Clover Creek Solar Project LLC d/b/a New Frontiers Solar Park
Responses to Siting Board Staff's First Request for Information
Case No. 2024-00253

Request No. 1:

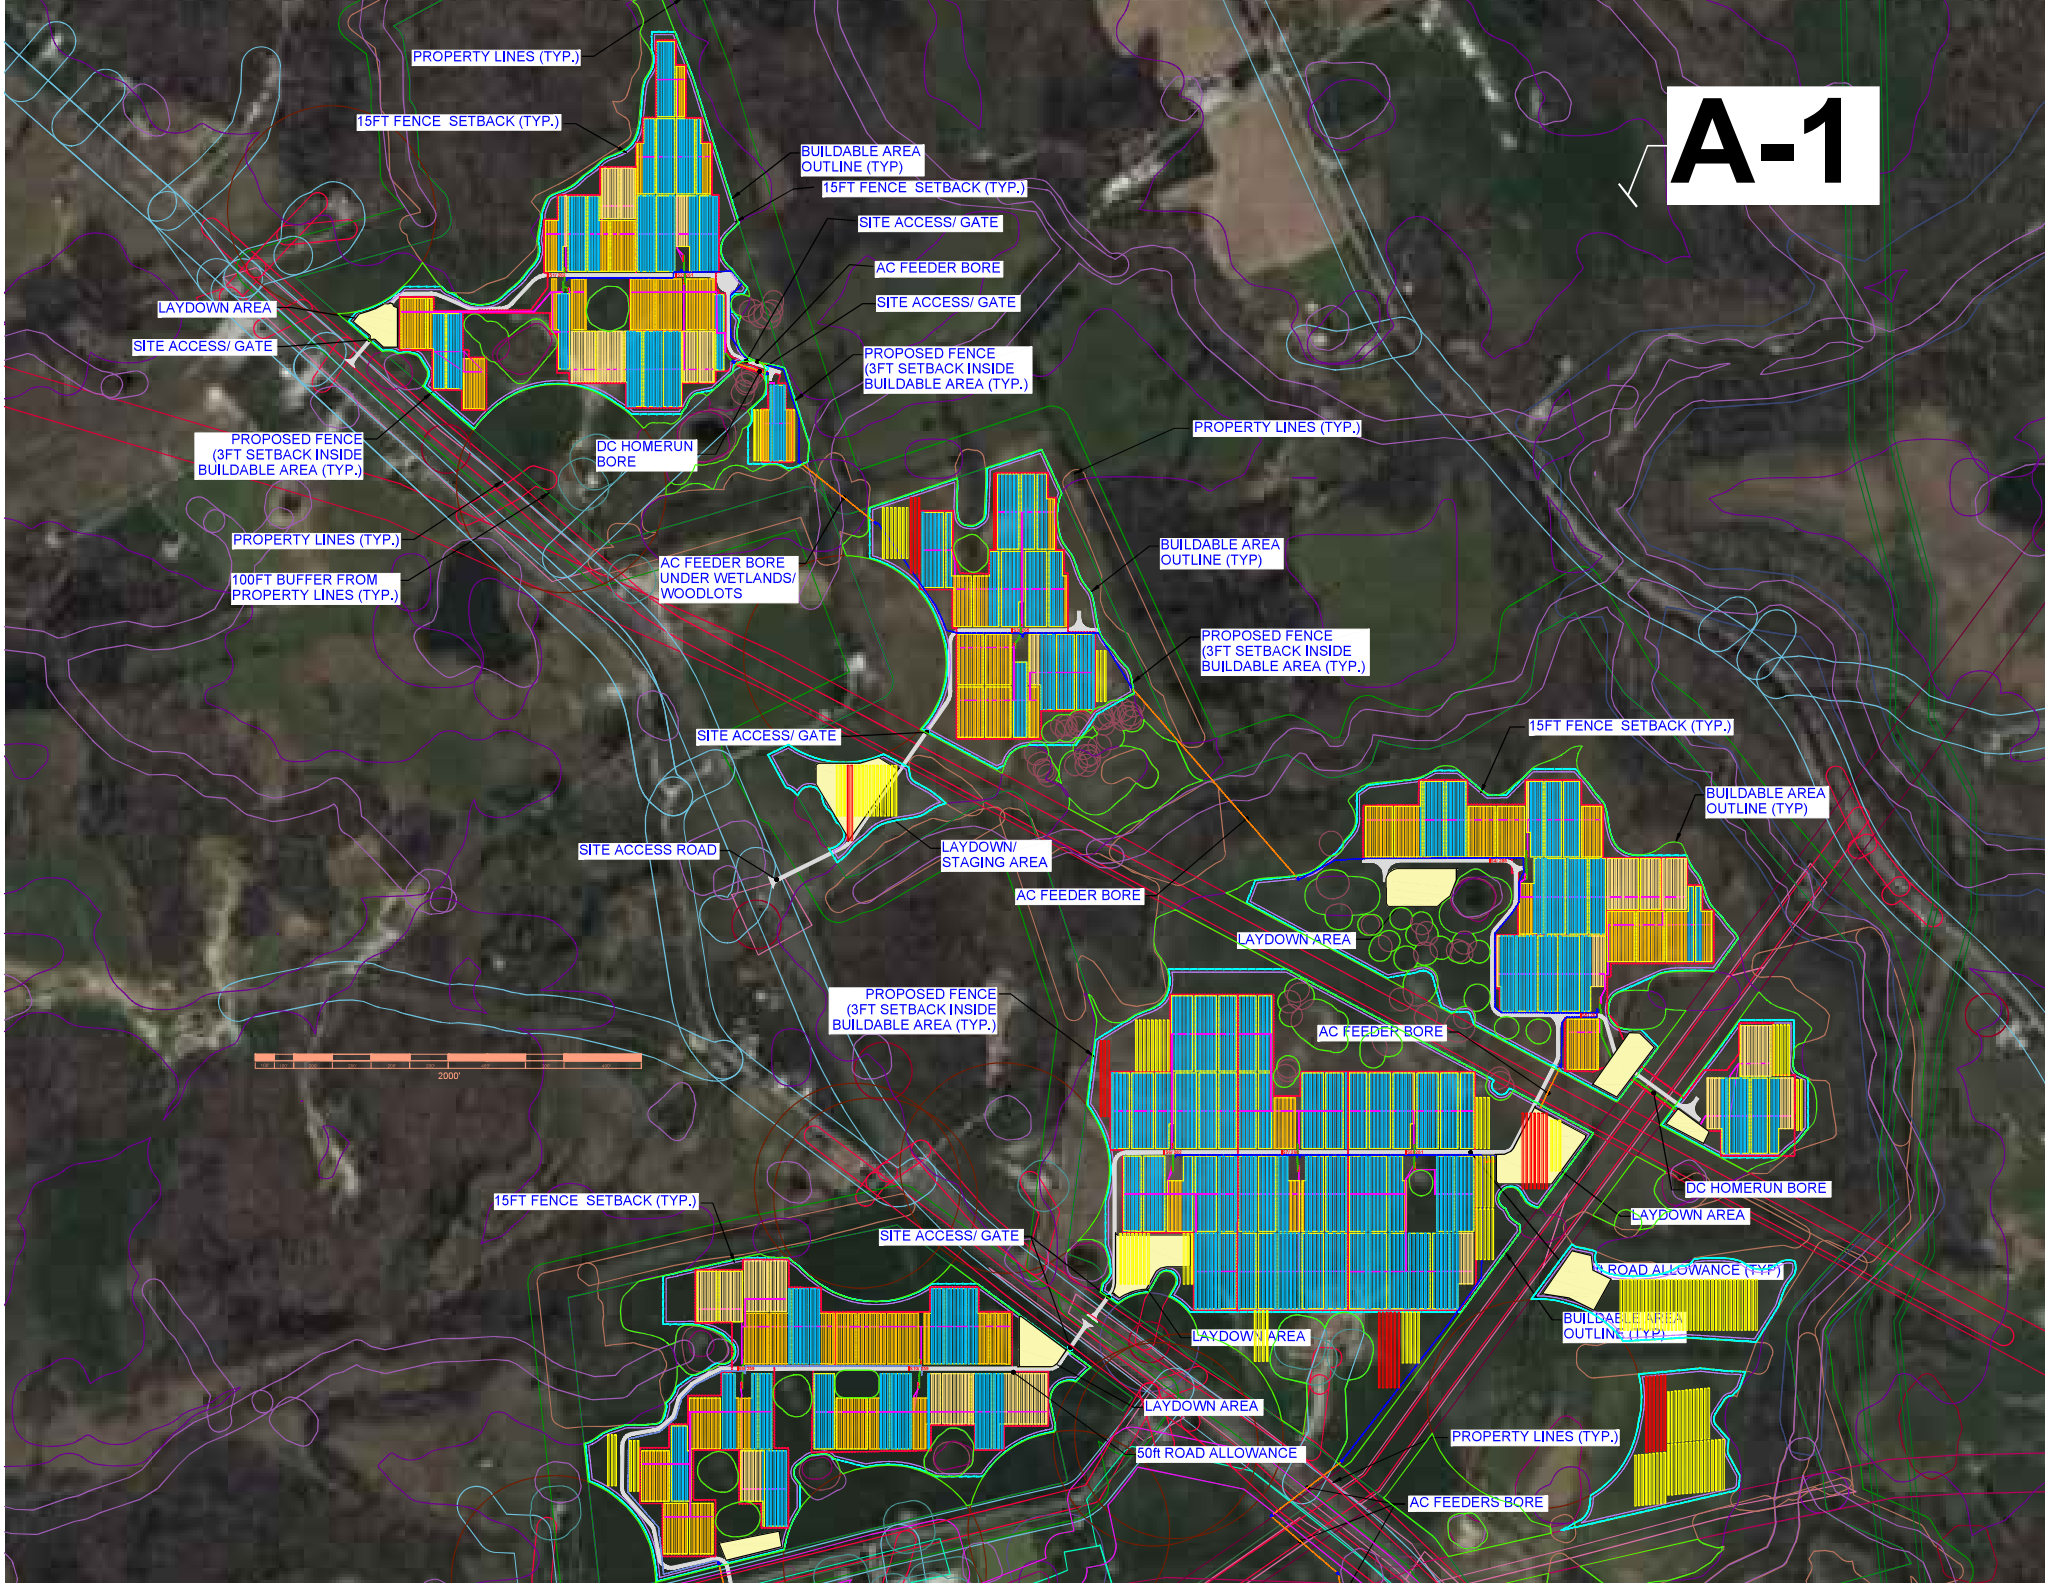
Refer to the Site Assessment Report (SAR), Attachment A, Preliminary Site Layout. The map that is provided is not legible. Provide an updated site plan for the proposed project that is of sufficient quality. Separate the site plan into discrete project areas and file the documents separately so each one can be accessed and enlarged.

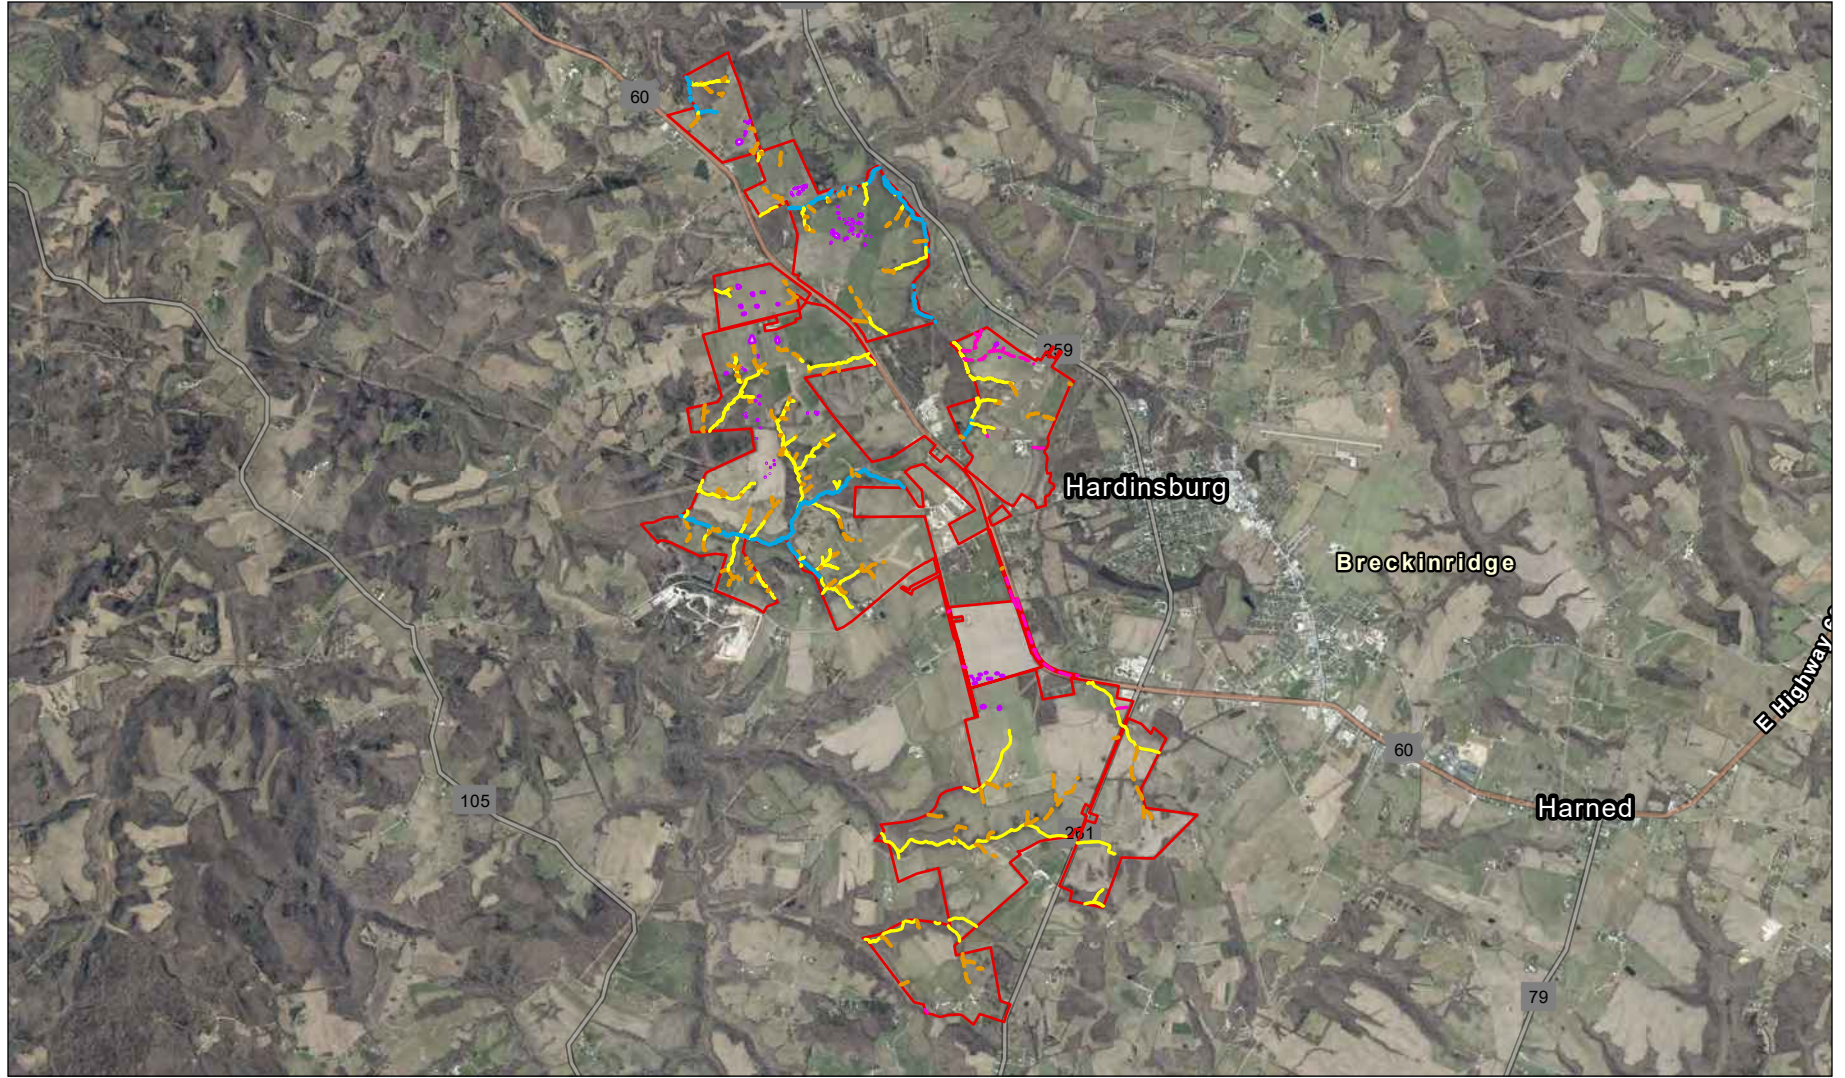
Refer to the SAR, Attachment A, Preliminary Site Layout. Provide a one page site map that contains the locations water features, including rivers, streams, lakes, and ponds. Also include any known or suspected karst features.

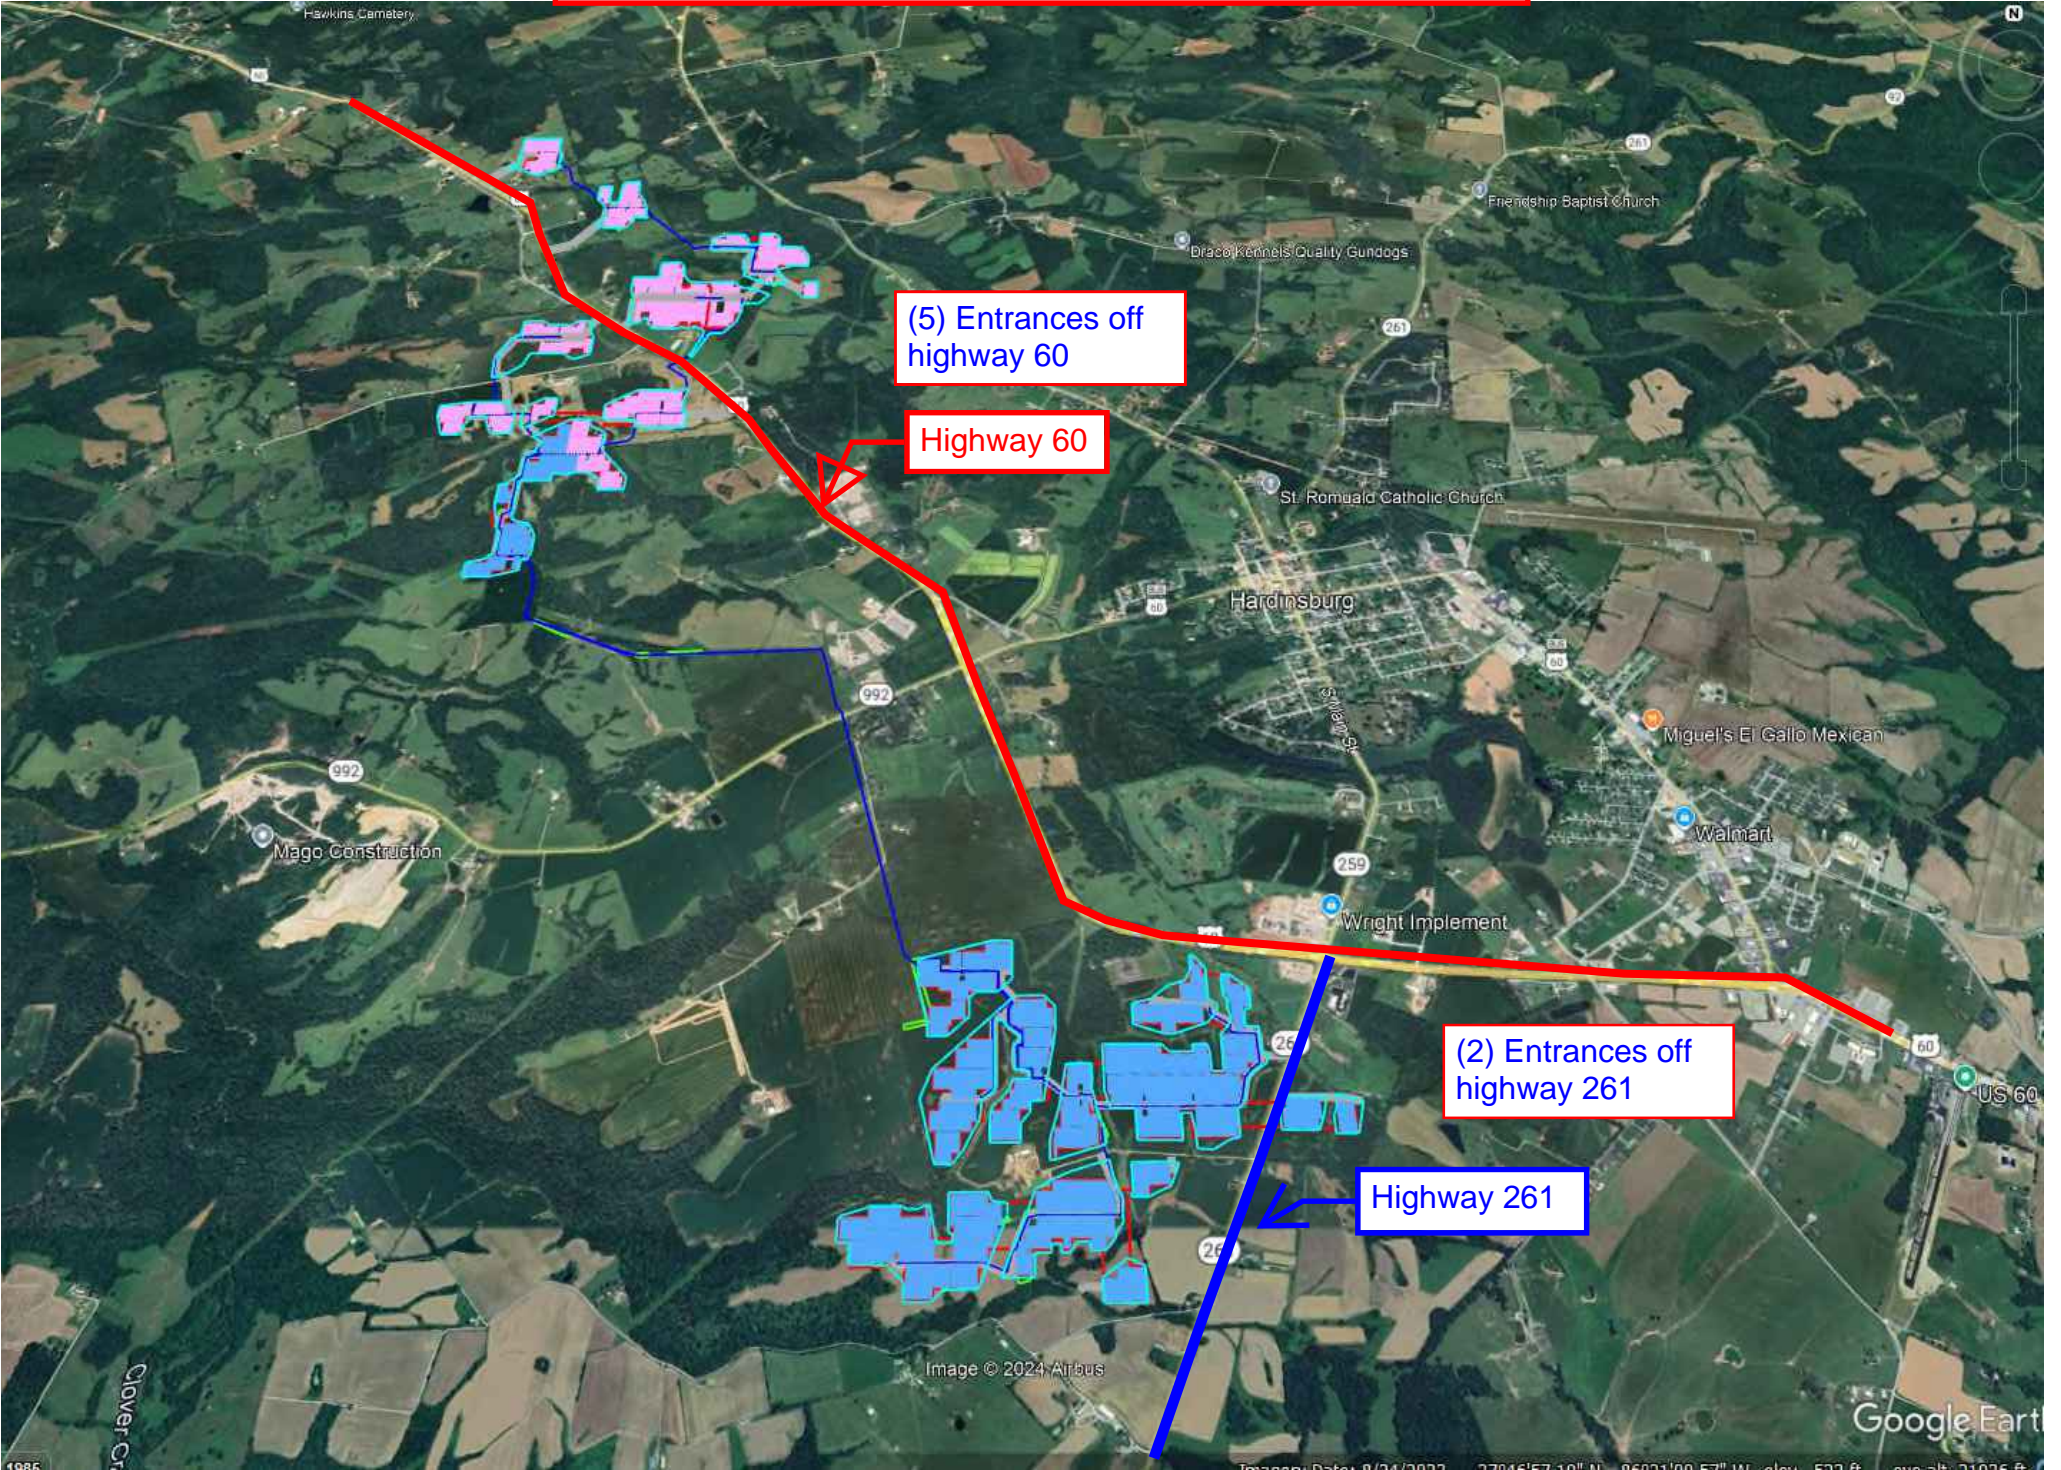
Provide a one-page directional map showing highlighted anticipated delivery routes for the project. Include on the map: access roads, access points, existing roads, bridges, electric generation components, and all structures within two miles of the project. Differentiate between roads and bridges that will and will not be used for deliveries.

Please see attached. Please also see the Table attached to Response No. 12.
